ECE/TRANS/WP.29/2007/95
19 July 2007

Proposal for Amendment 1 to gtr No. 2
(World-wide motorcycle emission test cycle (WMTC))

Submitted by the Working Party on Pollution and Energy (GRPE)

Figure 6-1: vehicle classification

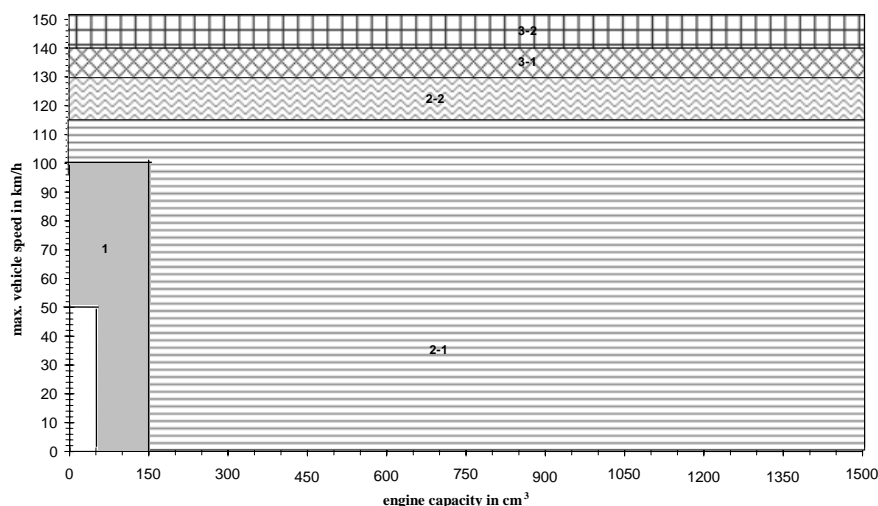
Paragraph 6.3.3., figure 6-1, replace by the following:

"6.3.1. Class 1

Vehicles that fulfil the following specifications belong to class 1:

$50 \text{ cm}^3 < \text{engine capacity} < 150 \text{ cm}^3$ and $v_{\text{max}} < 50 \text{ km/h}$

or

$\text{engine capacity} < 150 \text{ cm}^3$ and $50 \text{ km/h} \leq v_{\text{max}} < 100 \text{ km/h}$
